REMARKS

Amendments to the Drawings:

FIG. 1

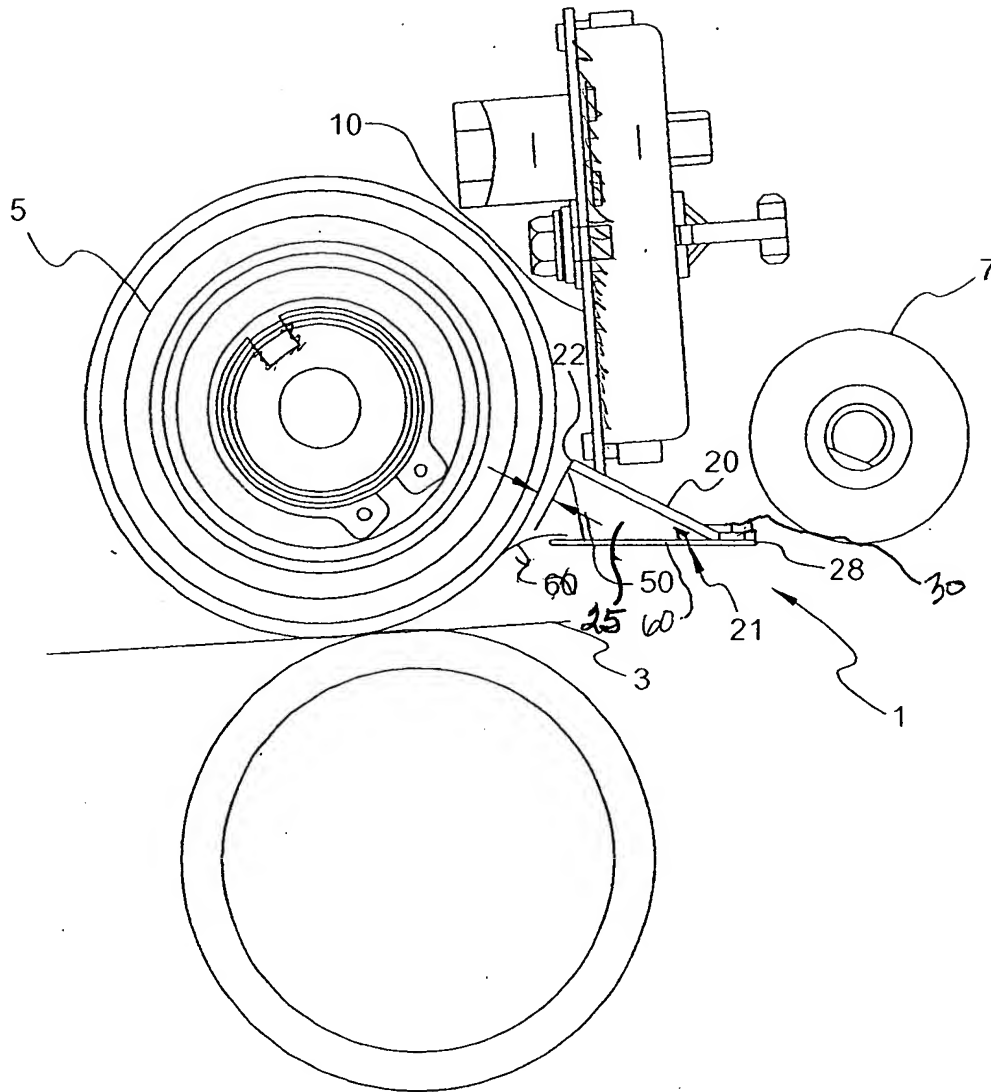
FIGs. 1-4 have been corrected based on the Examiner's recommendation and some minor changes made as indicated. These changes include the line from "50" in FIG. 1, the line to "22" in FIG. 4, the lines in FIGs. 1 and 3, and FIGs. 2 and 4 which the Applicants now believe clearly show the "distance between the terminal edge and the base plate decrease or the distance from said skive plate central portion", claimed in claim 1, and "the gap" claimed in claim 9.
